Scott Boule
Legislative Affairs and Community Outreach Manager
Transbay Joint Powers Authority
201 Mission Street, Suite 2100
San Francisco, CA 94105

Re: Comments on Transbay Joint Powers Authority (“TJPA”) and Federal Transit Administration (“FTA”) Transbay Transit Center Program Draft SEIS/SEIR dated December 15, 2015
Our File No.: 1875.06

EXHIBIT

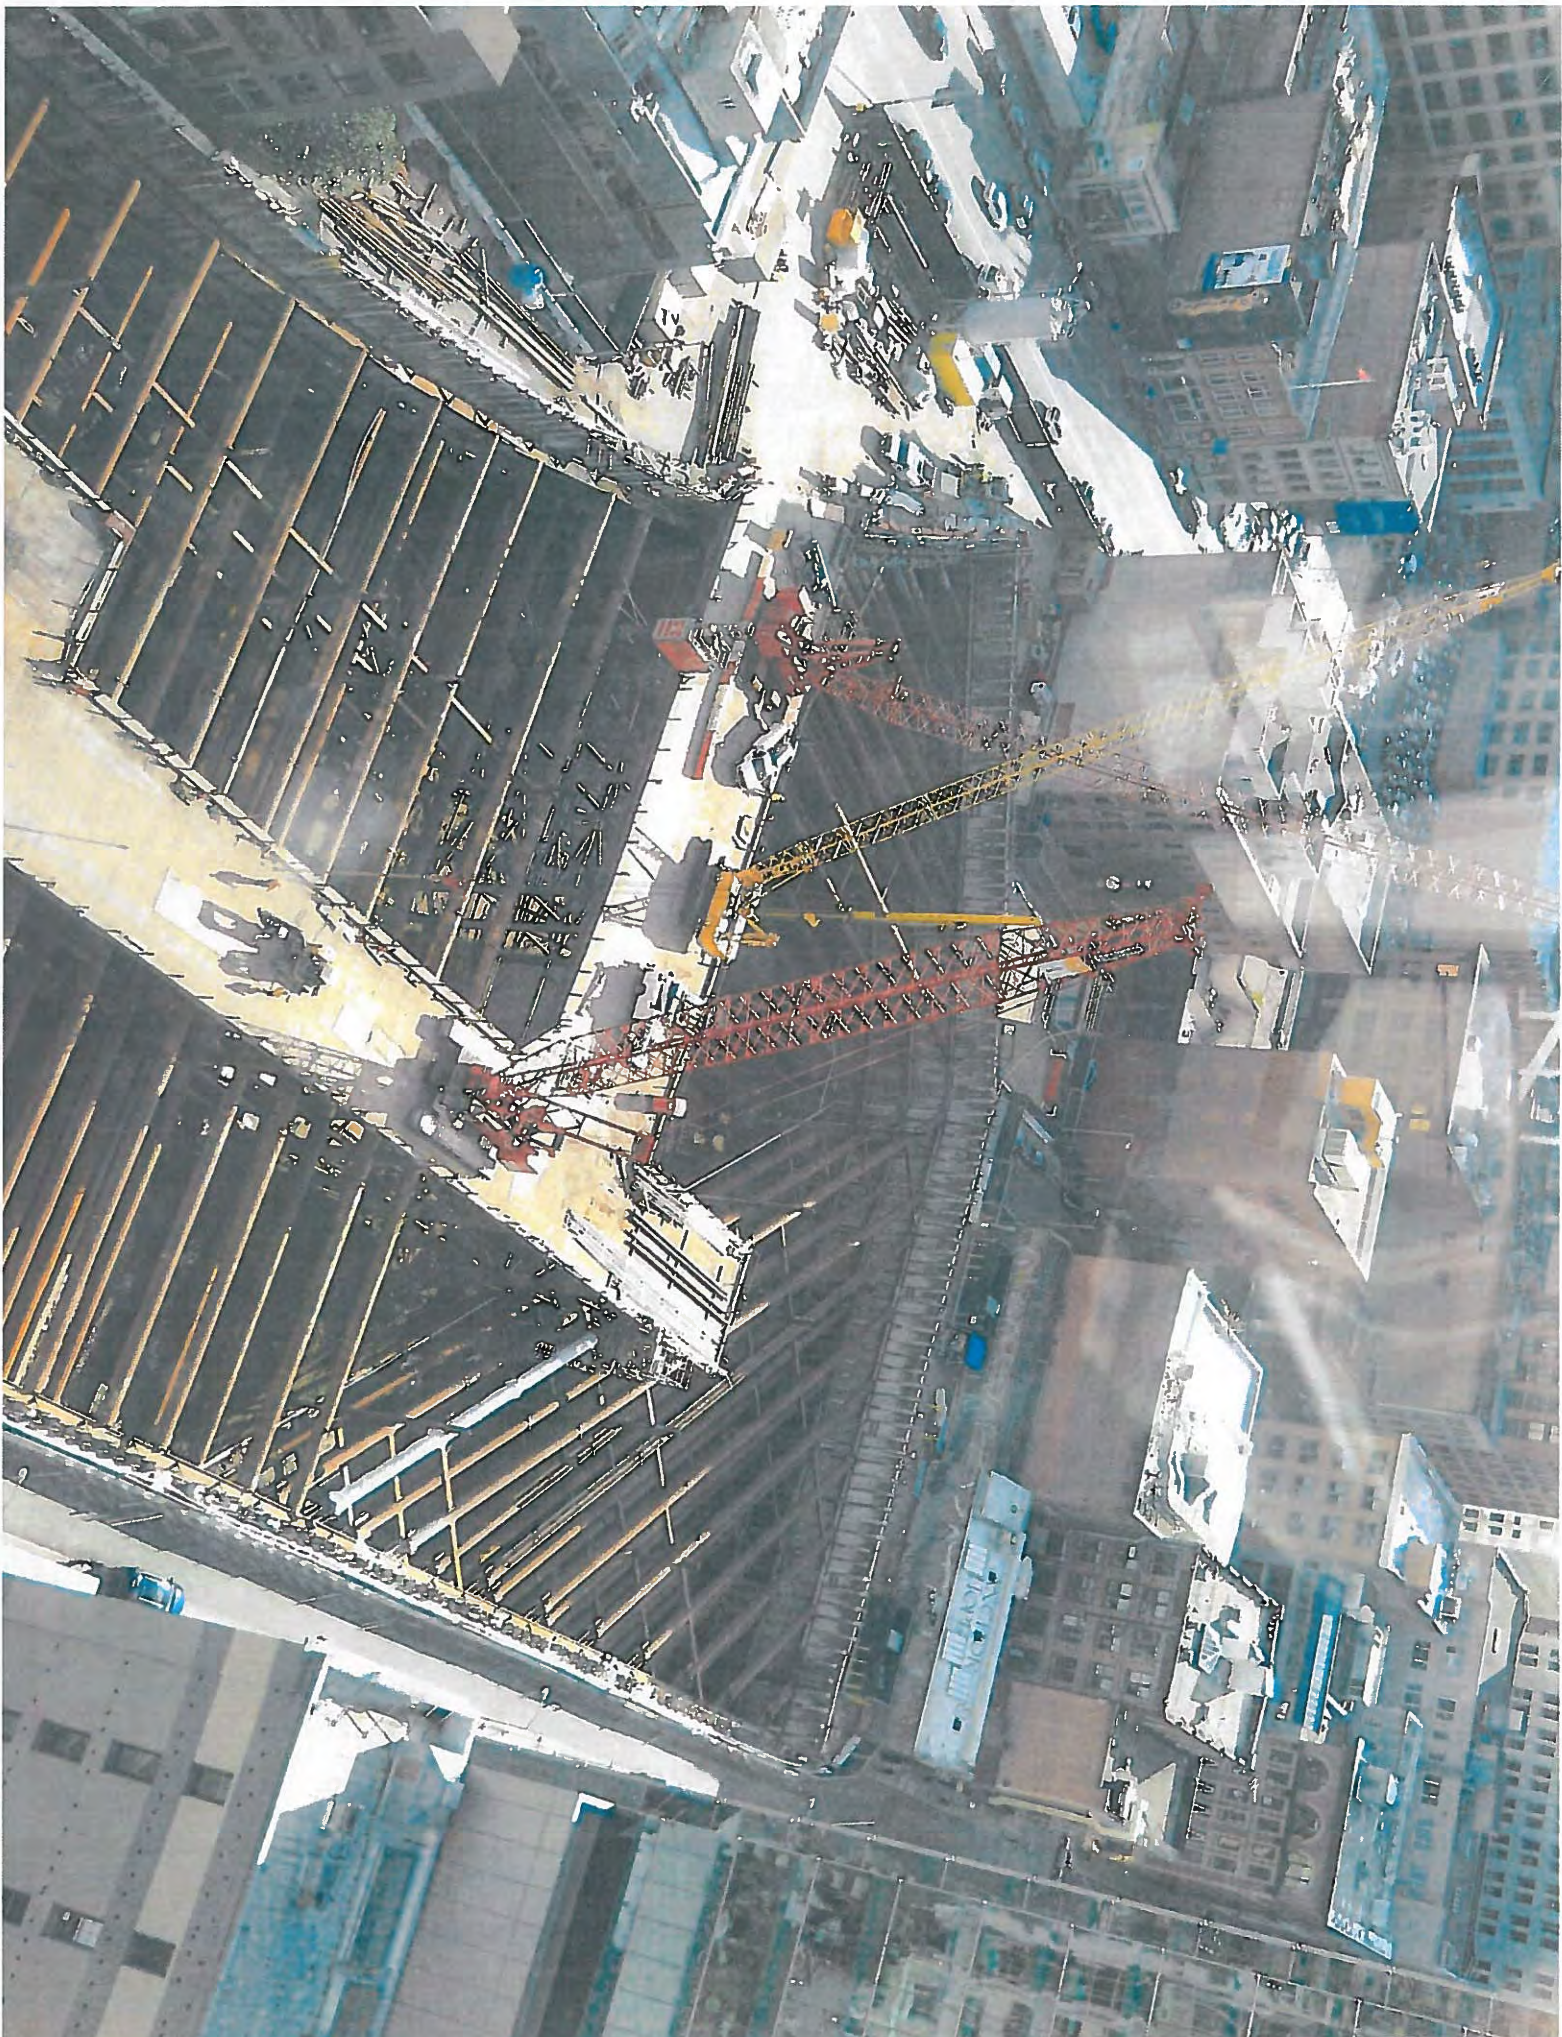
In fact, the ongoing construction of the Transbay Transit Center presupposes that the New DTX Curvature is a certainty. The enclosed photographs (Attachment A), taken in January 2013, show that the Transbay Transit Center has already been designed and is being constructed to align with the New DTX Curvature, despite the assertion in the SEIS/SEIR that the curvature is being evaluated for environmental impacts in a draft report dated December 15, 2016.

The photographs included in the commenter's letter show construction of the train box. The throat structure, which is the connection between the tunnel segment and the train box where the six tracks at the Transit Center would converge to three tracks in the tunnel segment, has not yet been constructed. Although the train box, as constructed, could be modified to accommodate other throat structure alignments, such modifications would have cost implications to reconfiguring the already built transit center. Therefore, although the design of the train box, as constructed, does not preclude other designs for the throat structure, many of

Recommendation #1

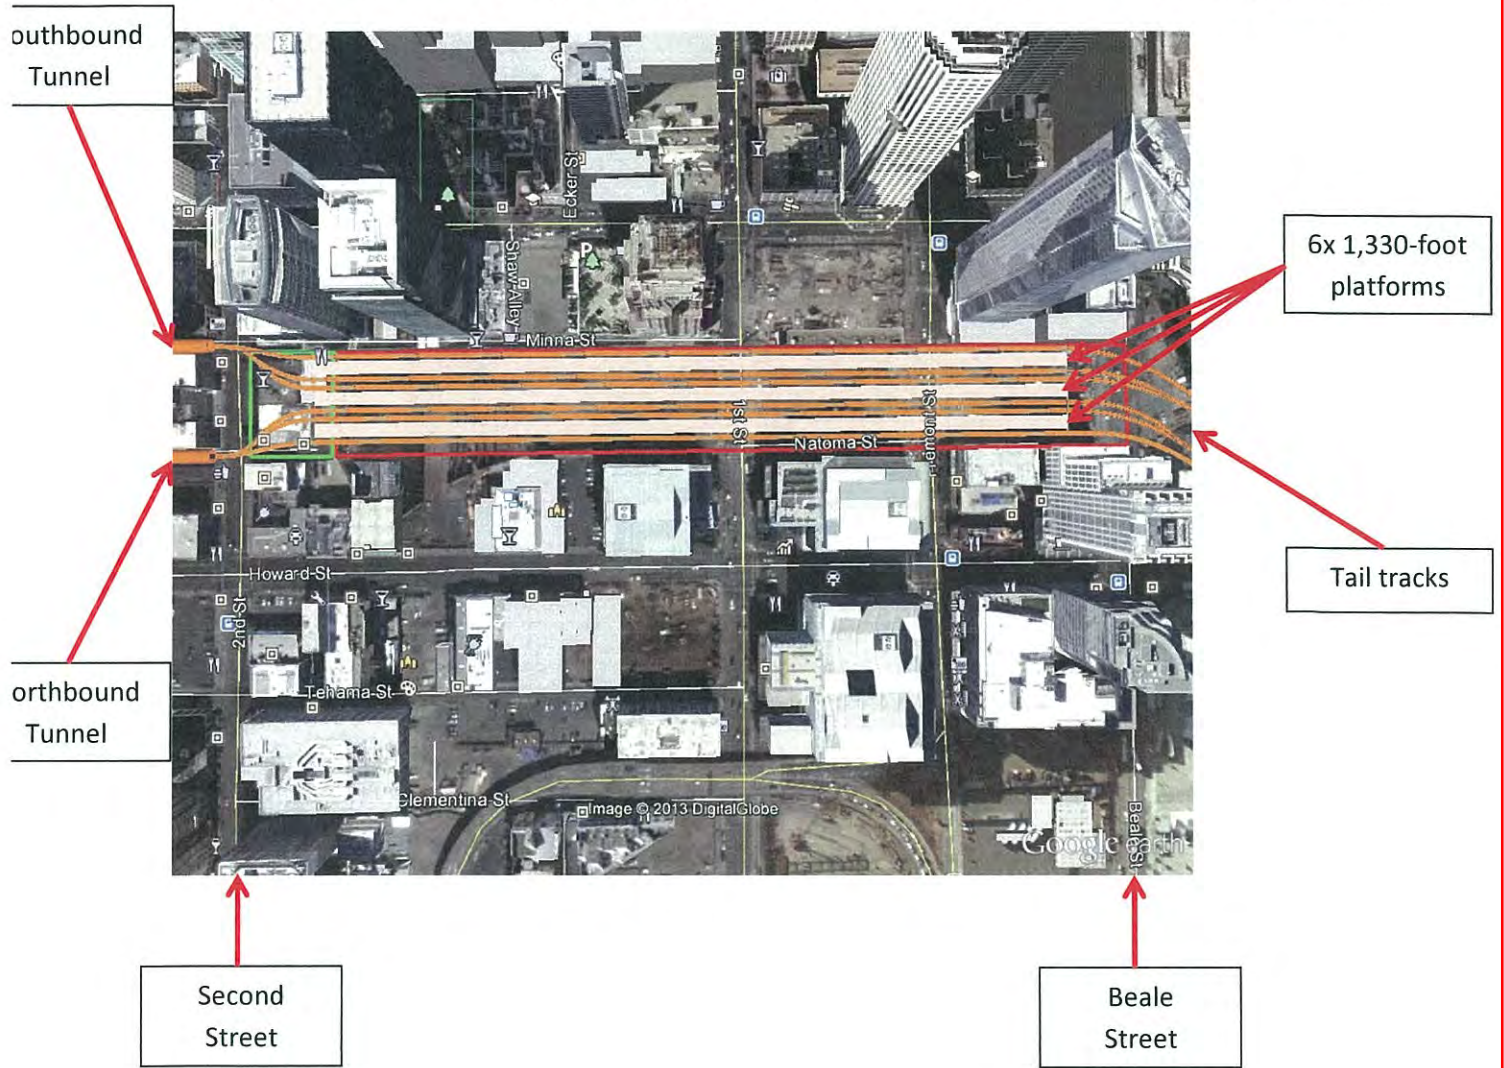
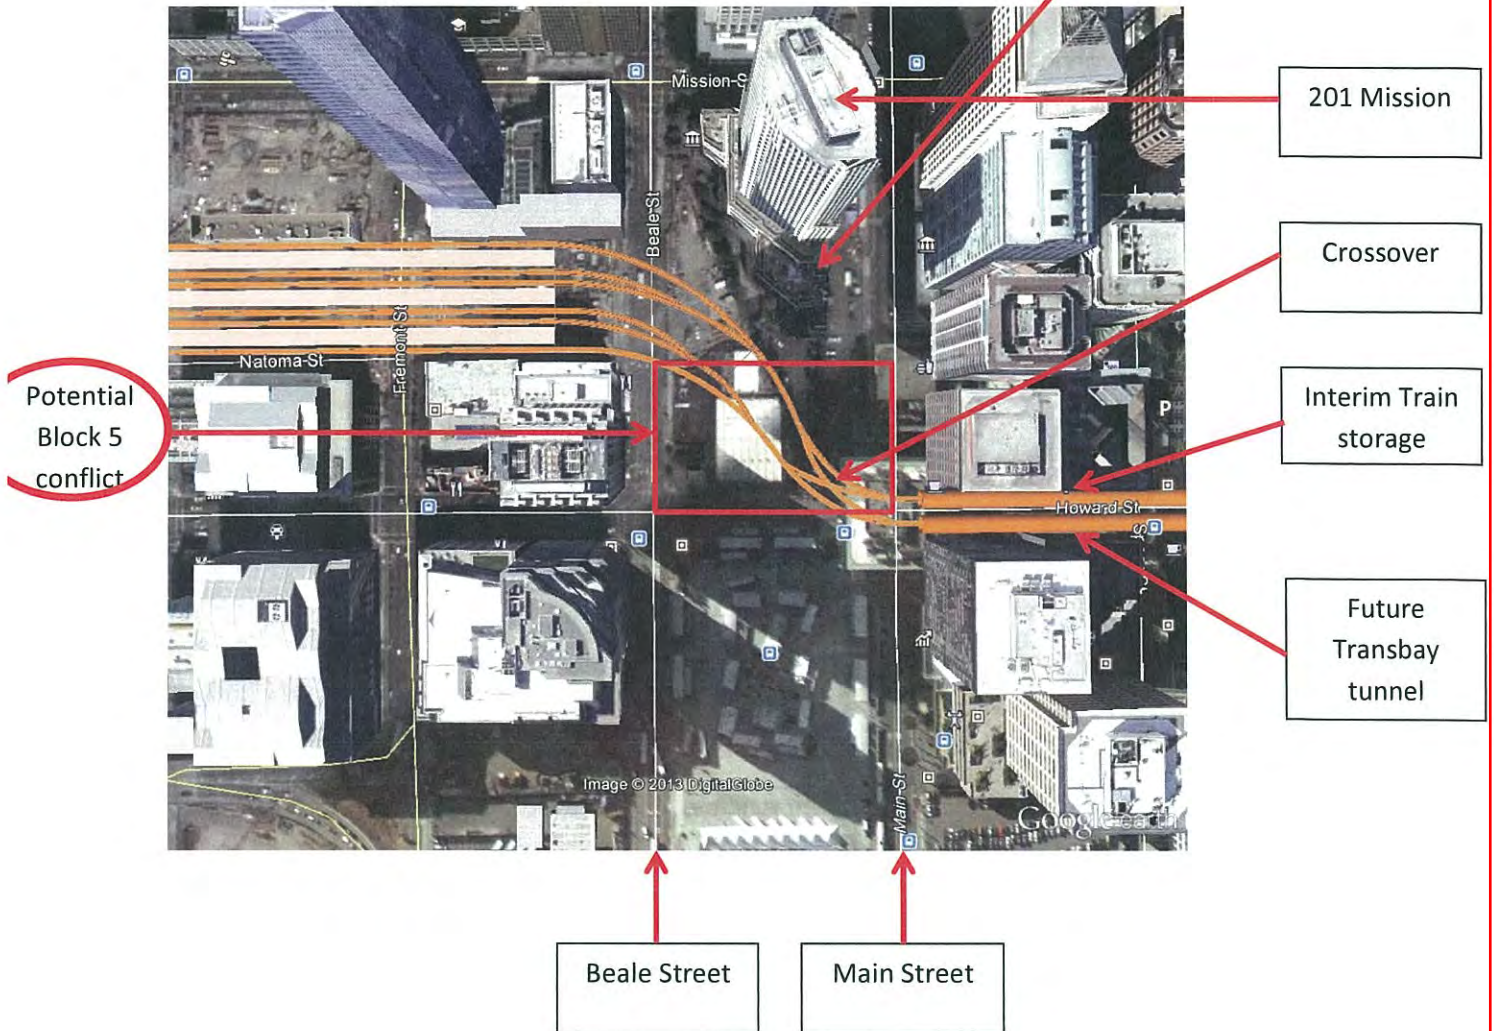
- The proposed Caltrain storage is insufficient to enable Caltrain to vacate the 4th & King railyard until after relocation to Oakland.

The SEIR should consider an alternate DTX alignment which would enable platform lengthening by extending the train box one block west (towards 2nd Street) while simultaneously providing a viable connection to a Transbay tunnel. This alignment would also eliminate conflicts with the 201 Mission building and enable a 6th full-length through platform (total 3 eastbound and 3 westbound platforms).

This alignment would eliminate the need to demolish the 201 Mission podium structure.

implications to reconfiguring the already constructed train box, as described above in the response to Comment Lebrun-01.

2) Widened throat structure

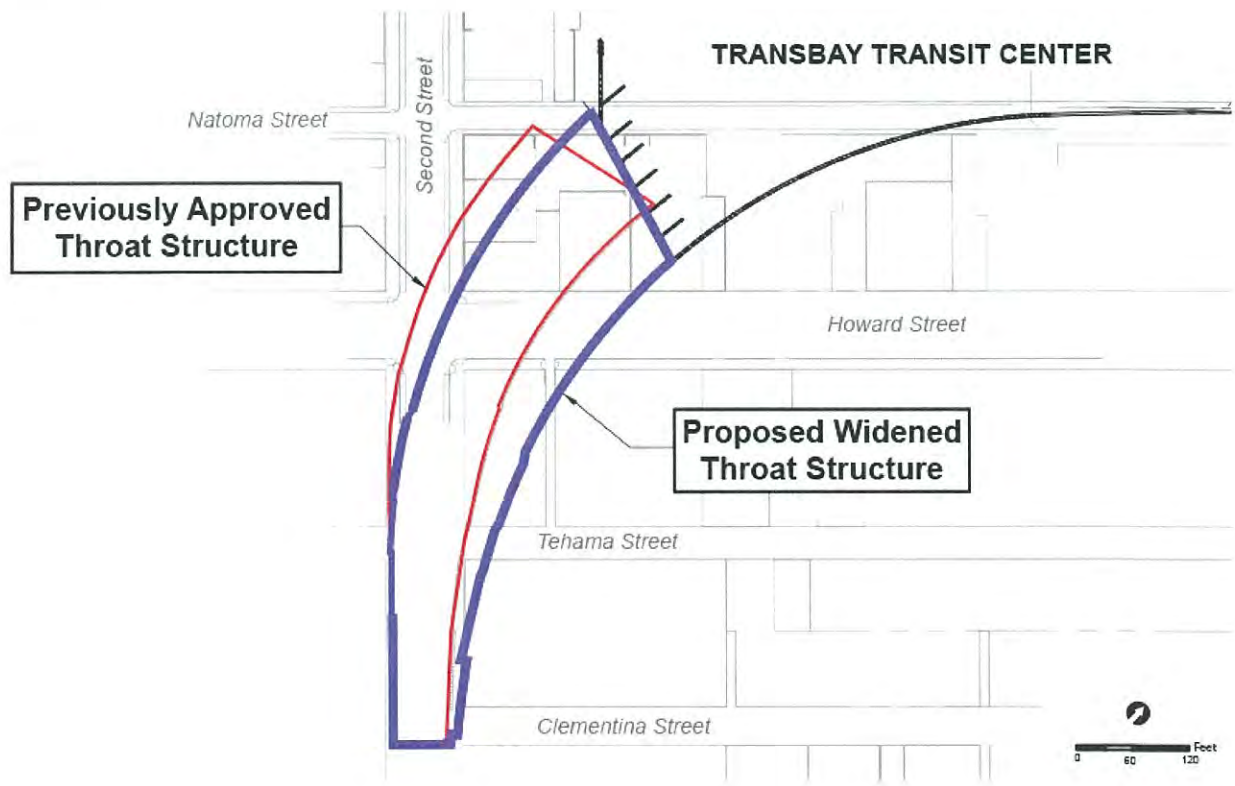
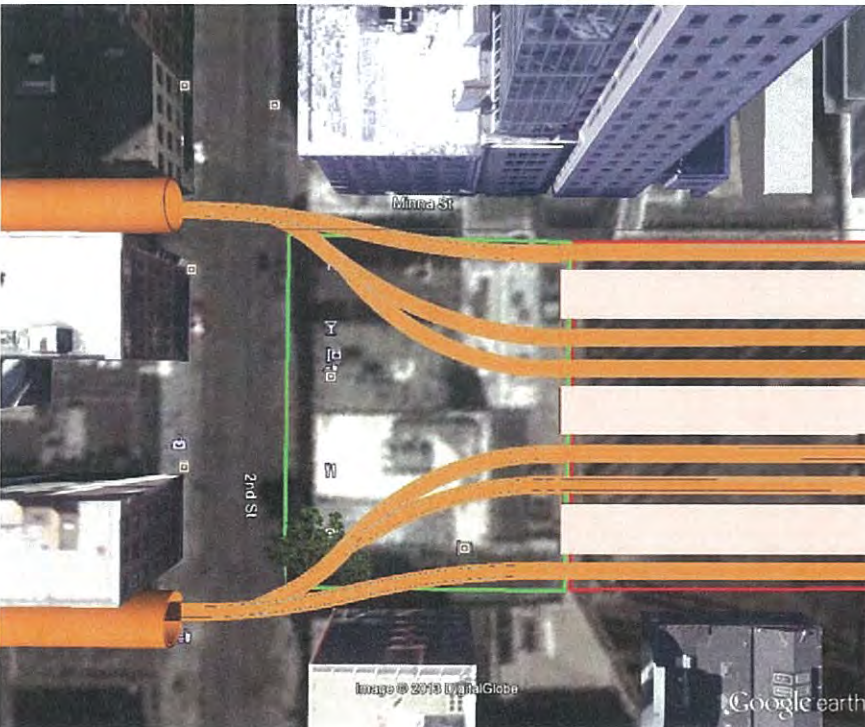
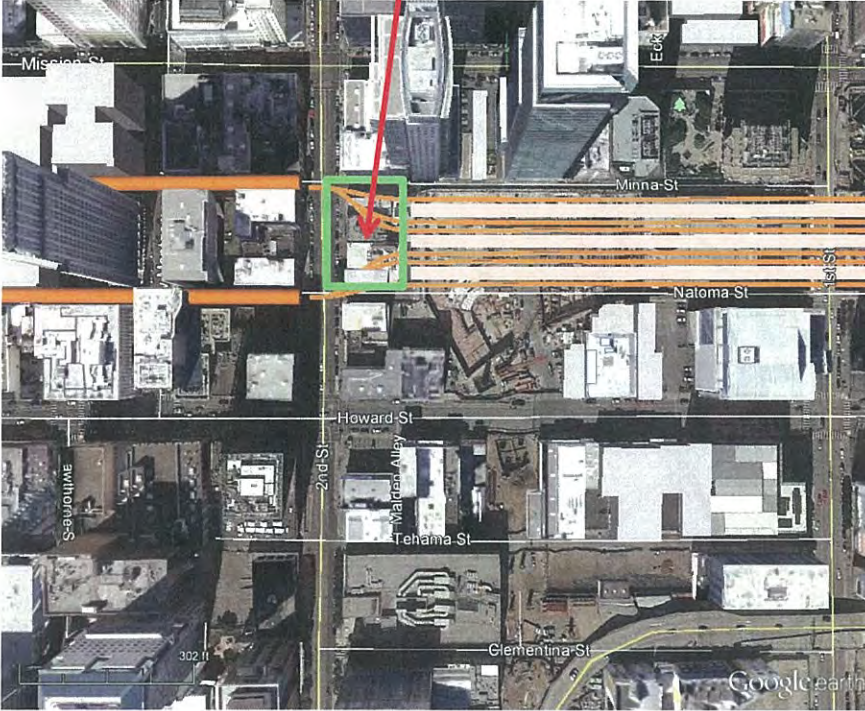
The SEIR proposes a widened approach to the Transbay Center train box via a massive cut & cover structure that will impact numerous properties as far south as Clementina Street. Construction costs are expected to run into the hundreds of millions and will result in massive circulation and noise impacts on the adjacent neighborhoods for many years.

The SEIR should consider an alternate DTX alignment and construction technique that would limit impacts to a small number of buildings on 2nd Street between Minna and Natoma. There would be no additional surface impacts in SOMA north of Townsend.

3) Tunnel design

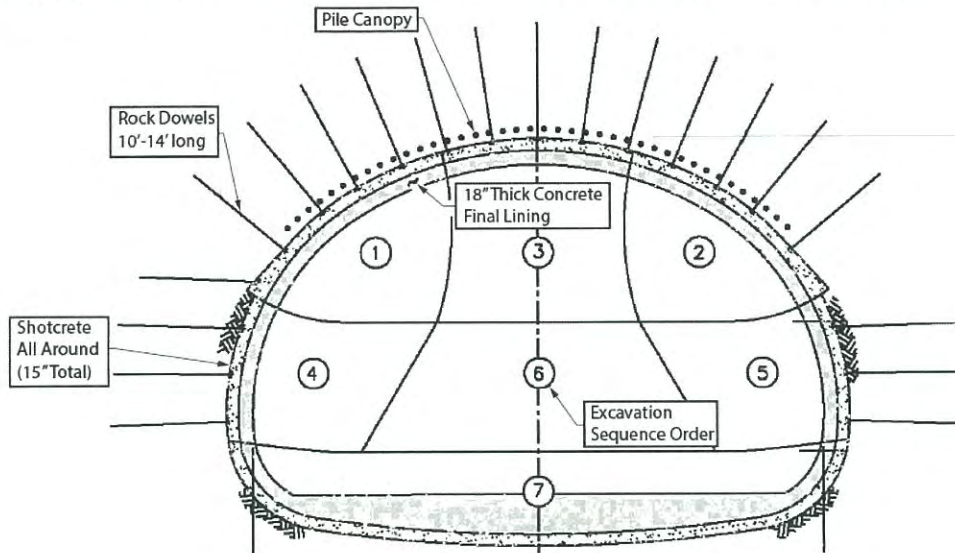
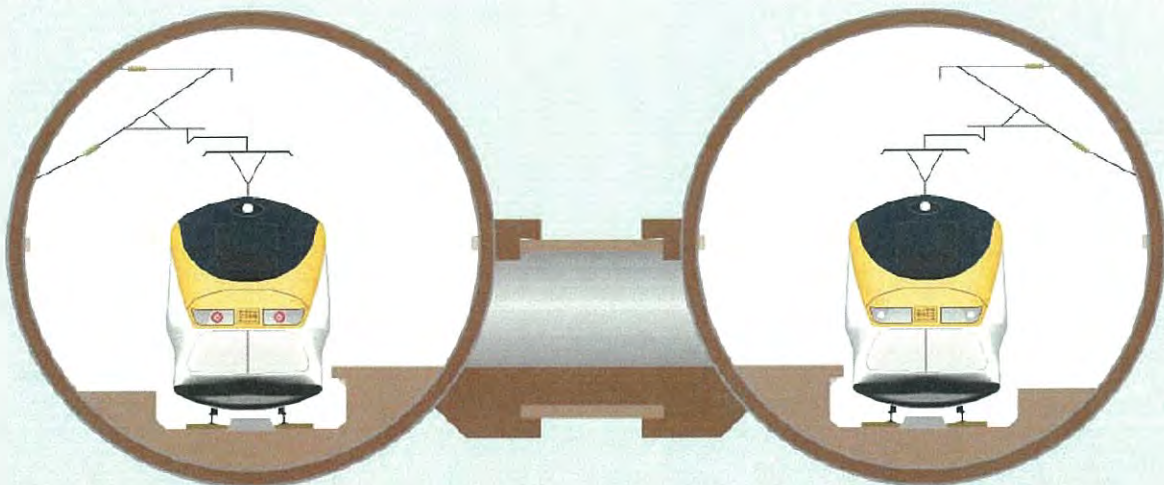
The current DTX design contemplates the construction of a 3-track sequentially excavated tunnel without any apparent plans for the evacuation of a train travelling on the middle track. This is of particular concern with High Speed trains which have a single door per carriage.

The SEIR should consider a twin-bore tunnel design with cross-passages for emergency evacuation (similar to the Central Subway) and a ventilation system designed to eliminate any requirement for vent/evacuation structures north of Townsend.

Twin-bore single-track tunnels, recommended by the commenter, would eliminate the operational flexibility required by Caltrain and CHSRA and that is provided by a third track. If the commenter's recommendation for tunnel design were to be implemented, the cross-passages required between the two tunnels for safety would likely need to be at least one block long and may necessitate cut-and-cover construction, which would be more disruptive to businesses and circulation than the approved tunnel plans. There would also need to be more of these cross-passages because the required time for egress would increase dramatically with such long cross-passages. Locating additional cross-passages would be technically and financially difficult due to the large number of existing buildings with deep foundations and below-grade parking.
